Access Compliance Report

Public Rights-of-Way

Intersection ID: 7380	Main Street: REAGAN_DR	Cross Street: W_SUGAR_CREEK_RD	Location: SW
ADA ID: 4A72E85CB373	Ramp Type: ParaDiag	Initial Pass/Fail: Fail	Overall Compliance: No
			Severity Score: 13.75

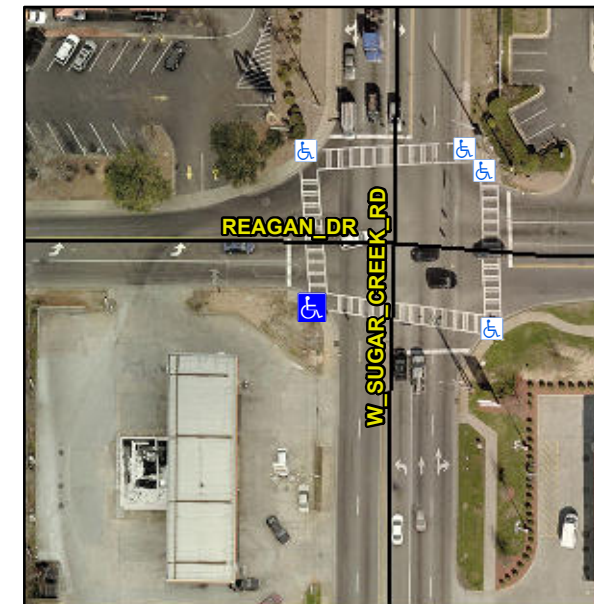
RT RP < 5%

R304.3.2, R304.5.3

Remove & Replace Curb Ramp With Two New Directional Ramps or Equivalent.
